**CAPITOL ZONING DISTRICT COMMISSION  
STAFF REPORT  
3/28/18  
BIM / JBC**

**Location:** 1512 South Spring Street  
**Owner:** Mizan Rahman & Elizabeth Barnett  
**Permit Type:** Certificate of Appropriateness (*amended*)

**Description:** This request is for an amended Certificate of Appropriateness to approve completed work that was not contemplated in an application approved by the Commission in October 2016. The application that was approved in October 2016 called for:

October 2017 – work complete

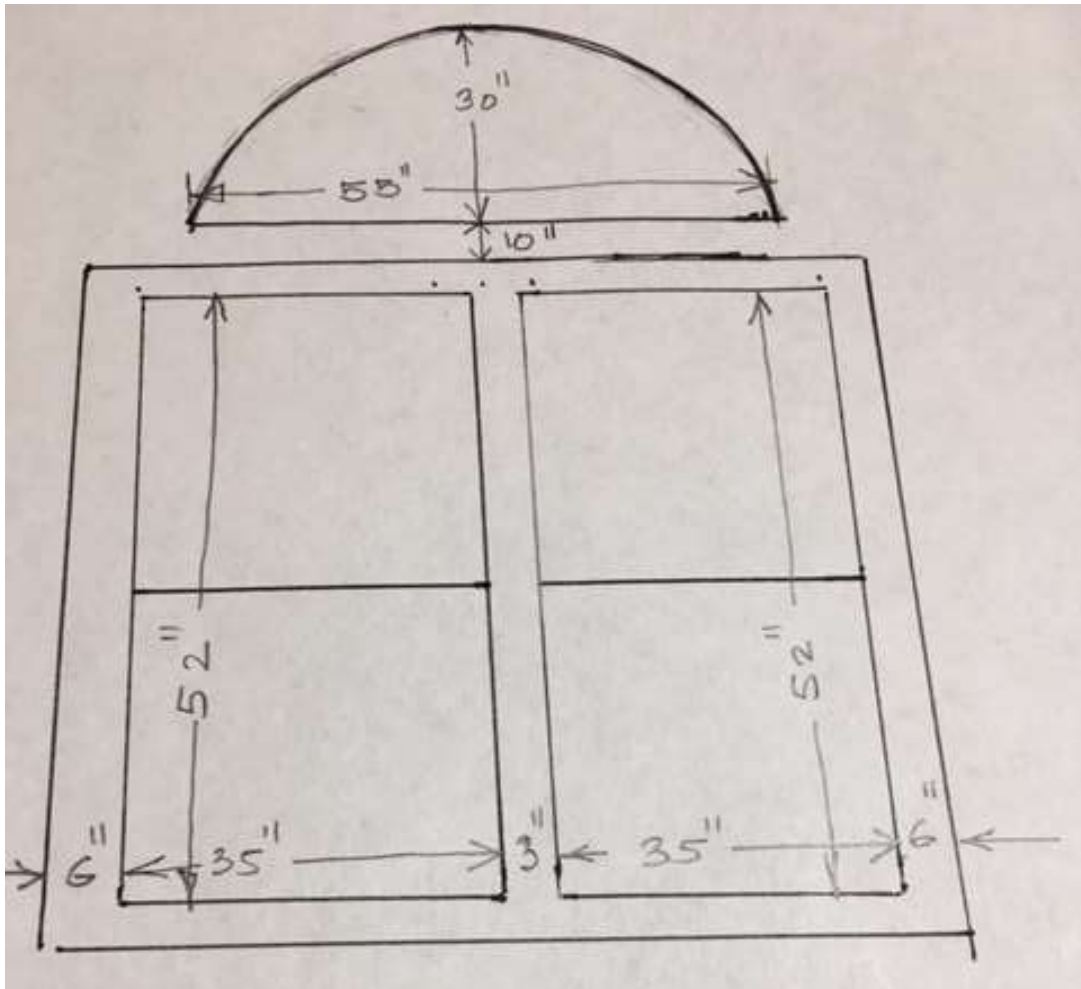
*Staff believes the installed fanlight (semi-circular window) on the front façade and decorative trim around the attic vent are not consistent with this principle.*

*Staff believes the installed fanlight (semi-circular window) on the front façade is NOT consistent with these standards. The applicant's request for an after-the-fact review of this window constitutes a request for a waiver of these standards.*

*Staff finds the replacement windows that were installed are NOT consistent with this standard. Though the windows they replaced were not original, staff does not believe the replacement models resemble the appearance of traditional wood windows in their dimension, profile, or finish. The applicant's request for an after-the-fact review of these windows constitutes a request for a waiver of this standard.*

*Staff finds the decorative trim around the attic vent is NOT consistent with this standard. The applicant's request for an after-the-fact review of these windows constitutes a request for a waiver of this standard.*

*Staff finds the windows and decorative trim installed on the front façade are not consistent with these standards.*

Still remaining though, are items 3, 4, and 5. Staff believes the proposal to replace the former metal windows with new windows resembling divided-light double-hung windows, like those seen traditionally in the neighborhood was an integral component of the approved work. Staff also believes the semi-circular windows installed above these is altogether different from the rectangular transom window that was approved for installation. Finally, staff believes that the reconfigured attic vent with decorative trim represents a substantial departure from the approved work, not consistent with the Standards.

Since a case of economic hardship is unlikely to be established here, and since the asterisked standards cannot otherwise be waived, staff must recommend **denial** of the request for one-over-one vinyl windows on the front façade, the semi-circular fanlight, and the repositioned attic vent with decorative trim.

**Design Review Committee Recommendation:** The applicants were not present. The Committee voted unanimously (9-0) to concur with staff's recommendation of **denial**. Several members also expressed that installing the 30x60" windows shown in the original application should be required.
